### **D.3.1 Recirculated Portions of Draft PEIR**

Subject: McClellan - Palomar Airport Master Plan Update  
SCH#: 2016021105

Re: Comments on Recirculated Portions of the McClellan-Palomar Airport Master Plan Update Draft Program Environmental Impact Report

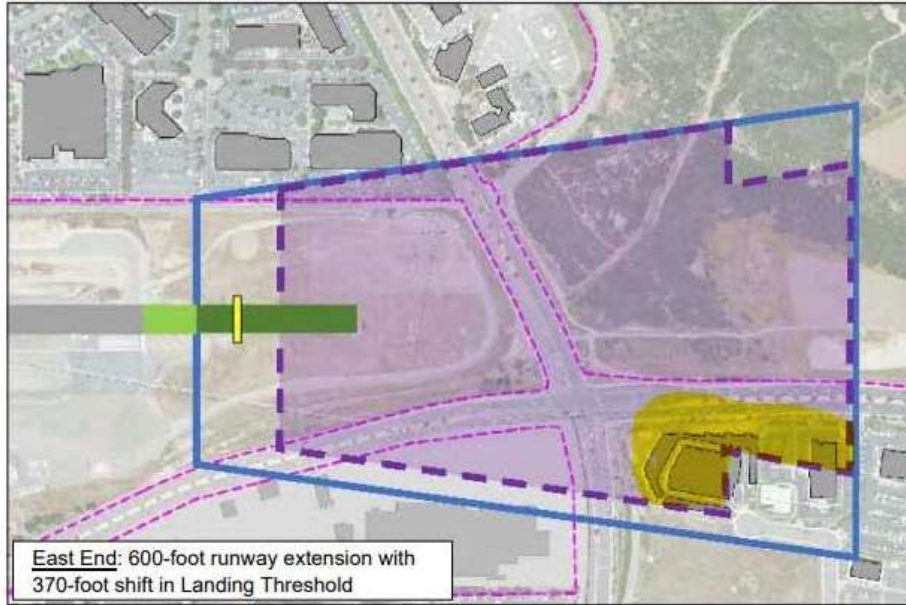
The County also disagrees that the PEIR relied on the County CAP Consistency Checklist solely as a means for determining consistency. As the comment itself explains, the PEIR disclosed that the Proposed Project emissions were not included in the CAP; therefore, a consistency determination cannot be made. To clarify, the published PEIR Section 3.1.5 states, "*because the CAP and the County GHG Guidelines are based upon the land use assumptions of the 2011 General Plan, the fact that the Airport Master Plan improvements were not included in the 2011 General Plan means that the CAP cannot be used to streamline the review of GHG emission from the Proposed Project... As such, although the CAP cannot be used to streamline the review of GHG emissions from the Proposed Project, a Project-specific climate change analysis was completed in compliance with the CAP to analyze potential Project-related impacts and to show consistency with the CAP.*" In other words, although the Proposed Project cannot rely on the CAP Consistency Checklist, the PEIR Section 3.1.5 discusses the applicable methodology for evaluating project-specific emissions, and elements of the County's CAP and how the airport, and the project comply with CAP's measures. PEIR Section 3.1.5.2.2 Conflict with Plans, Policies or Regulations discusses the applicability of GHG reduction plans and specific CAP measures and strategies implemented at Palomar Airport and system-wide for public projects including other airports. While the reduction of aircraft-related emissions are not within the County's jurisdiction to regulate and are not in the CARB Scoping Plan or County's CAP, the Proposed Project is consistent with applicable measure for County-owned facilities and

would not impact or impede implementation of the CAP. No changes have been made to the PEIR.
